# UNITED STATES PATENT AND TRADEMARK OFFICE

APPLICATION NO.	FILING DATE	FIRST NAMED INVENTOR	ATTORNEY DOCKET NO.	CONFIRMATION NO.
10/590,580	10/23/2006	Richard Fouquer	011460.00037	1073
26712 7590 02/21/2008 HODGSON RUSS LLP THE GUARANTY BUILDING 140 PEARL STREET SUITE 100 BUFFALO, NY 14202-4040				
EXAMINER				
ADDRESSEE, SARA				
ART UNIT		PAPER NUMBER		
3722				
MAIL DATE		DELIVERY MODE		
02/21/2008		PAPER

### Office Action Summary

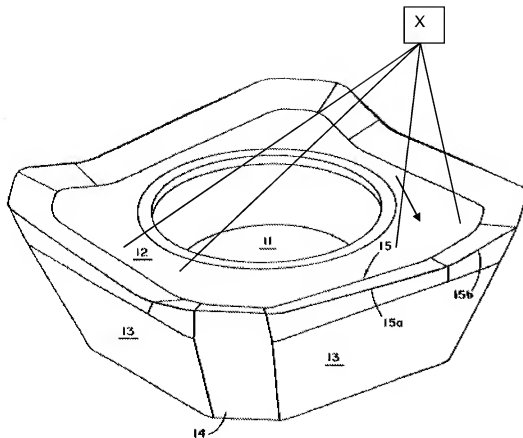
Claims 1, 2, 5, 7-10, 12, 13 and 15, as best understood, are rejected under 35 U.S.C. 102(b) as being anticipated by Satran et al. (EP 0548752 A1).

Regarding claims 1, 2 and 10, SATRAN ET AL teaches an indexable cutting insert comprising an anterior layer cutting head portion (i.e. top portion) comprising mutually inclined lateral faces (X: see figure below) of an anterior periphery and delimiting together with a large anterior face (12), a front view profile formed by a certain number of cutting edges (15a, 15b) mutually inclined in the direction (see arrow below) of said profile, and a posterior layer portion (i.e. bottom portion), constituting an anchoring base on a tool holder, comprising planar lateral faces (13) of a posterior periphery, at least some of which are framing supporting faces on walls of a seat of the tool holder (16), characterized in that the posterior periphery (13) comprises a smaller number of lateral framing supporting faces than the number of cutting edges (i.e. there are four posterior lateral faces (13) while there are eight cutting edges (15a & 15b) ('752, figure 1). Regarding claims 7 and 8, SATRAN ET AL teaches the lateral framing supporting faces of the insert having an overall truncated pyramid shape ('752, figure 1

and also as evidenced by USP 5,951,214, col. 1, lines 30-32). Regarding claims 5 and 9, as best understood, SATRAN ET AL teaches in figure 5, said successive lateral framing supporting faces being joined together forming an angle of less than 180 degrees between them and defining periphery having a uniformly varying orientation (i.e. formed by the "v shaped" of each face with different tapers) ('752, figure 5). Regarding claims 12, 13 and 15, SATRAN ET AL teaches said cutting insert being held in a tool holder for a whereby the tool holder comprises a seat including a bottom, associated with insert clamping means (not shown but it is well known in the art to clamp the insert with a screw going through it's central through hole), and lateral walls for receiving posterior framing support sides (13) of the insert and the walls of the seat are flared (i.e. the sides that contact the support faces of the insert) in relation to the bottom thus forming, together with the bottom seat surface, an angle slightly exceeding 90 degrees, because the insert has a truncated pyramid shape ('752, figure 2).
